Subject: Request for Authorization to Perform Bank Line Repair and Maintenance Activities at Terminal 117, River Mile 4.1 Duwamish Waterway, Seattle, Washington

This letter is our response to your comments transmitted to me via telephone on Tuesday and Thursday, June 3 and June 5, with regard to our letter to you dated May 29, 2008 requesting authorization to perform bank line repair and maintenance activities at Terminal 117.

| PORT OF SEATTLE TERMINAL 117 | | GRAVEL REMOVAL AND PLACEMENT |

**T-117 TEMPORARY BANK REPAIR
GENERAL NOTES**

FIGURE 2

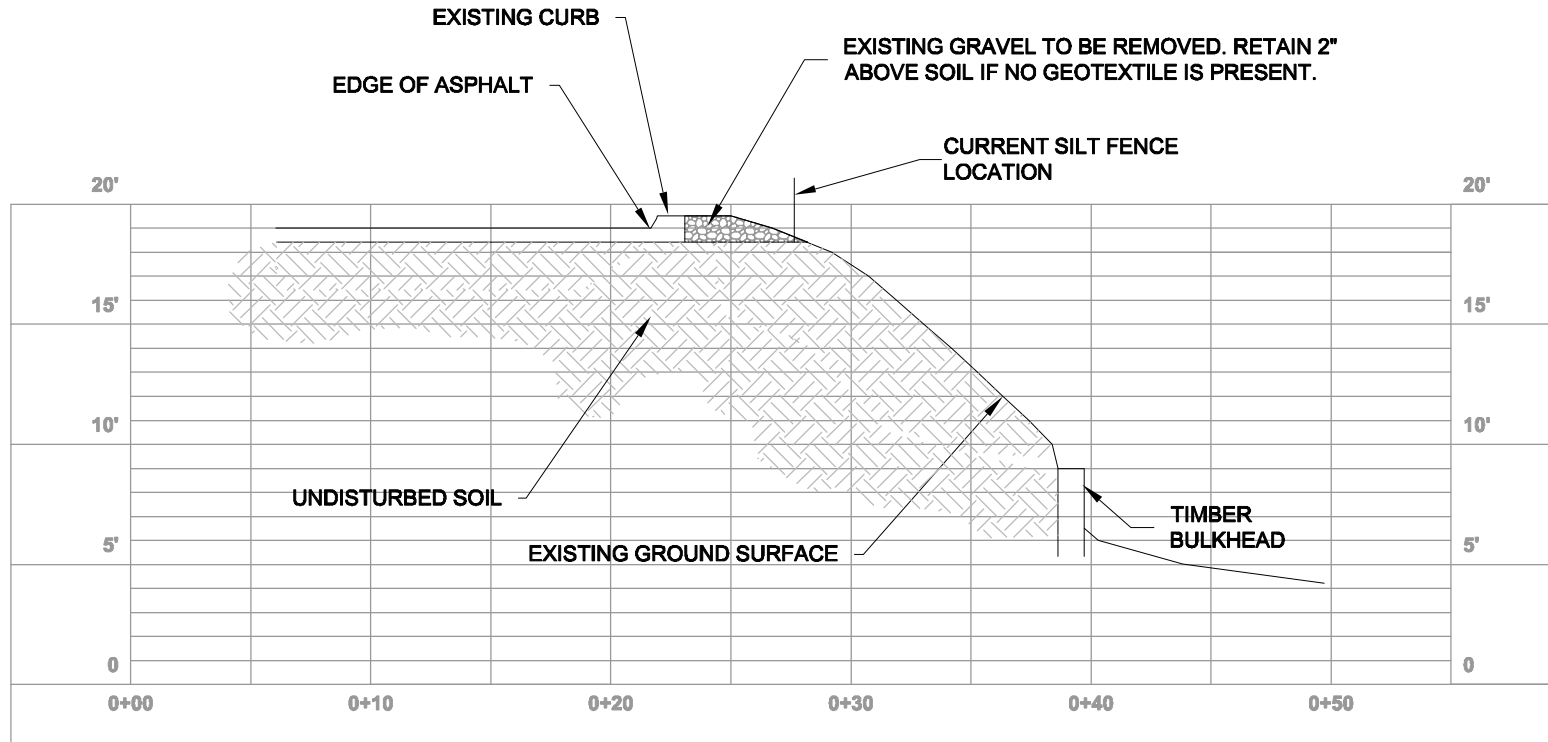
In addition to the above modification, you requested a clarification of the gravel removal activity, Item (1) listed above. Therefore, we are submitting (attached) two modified drawings describing in the greater detail the gravel removal activity.
